Access Compliance Report

Public Rights-of-Way

(Curb Ramps)

Intersection ID: 11835	Main Street: BELMONT_AV	Cross Street: N_DAVIDSON_ST	Location: S
ADA ID: A30DCB47A012	Ramp Type: PerpDiag	Initial Pass/Fail: Fail	Overall Compliance: No
Severity Score: 13.75			
Codes/Mitigation Info/Possible Solution		Field Measurements/Component Compliance

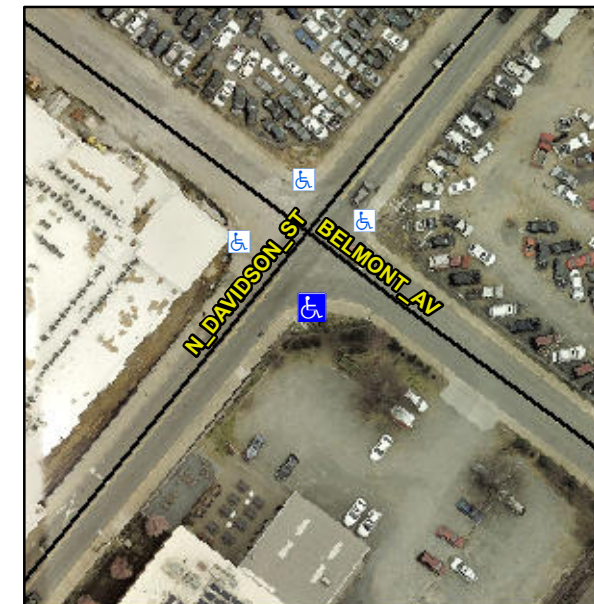
Not Found, R304.2.2, R304.5.3

Compliance	Description	Data	Compliance	Description	Data
N/A	Ramp Length (in)	66.0	No	Ramp Slope (%)	10.8
Yes	Ramp Width (in)	59.0	No	Ramp XSlope (%)	4.9
N/A	Flare Type LT	N/A	N/A	Flare Type RT	N/A
N/A	Flare Slope LT (%)	N/A	N/A	Flare Slope RT (%)	N/A
N/A	Flare Traversable LT?	N/A	N/A	Flare Traversable RT?	N/A
N/A	Landing Length (in)	N/A	N/A	DWS Provided?	N/A
N/A	Landing Width (in)	N/A	N/A	DWS Contrast?	N/A
N/A	Landing Slope (%)	N/A	N/A	DWS Length (in)	N/A
N/A	Landing X Slope (%)	N/A	N/A	DWS Full Width?	N/A
N/A	Landing Curb? (Y/N)	N/A	N/A	DWS Offset (in)	N/A
N/A	Shared Landing?	N/A			
N/A	Gutter Ponding?	N/A	N/A	Gutter Slope (%)	N/A
N/A	Gutter Lip Ht (in)	N/A	N/A	Gutter X Slope (%)	N/A
N/A	Painted X Walk1?	No	N/A	Painted X Walk2?	No
	X Walk 1 Direction	To NE		X Walk 2 Direction	To NW
N/A	X Walk 1 Width (in)	N/A	N/A	X Walk 2 Width (in)	N/A
	X Walk 1 Slope (%)	1.7		X Walk 2 Slope (%)	3.6
	X Walk 1 X Slope (%)	3.3		X Walk 2 X Slope (%)	1.3

Remove & Replace Curb Ramp With Two New Directional Ramps or Equivalent.
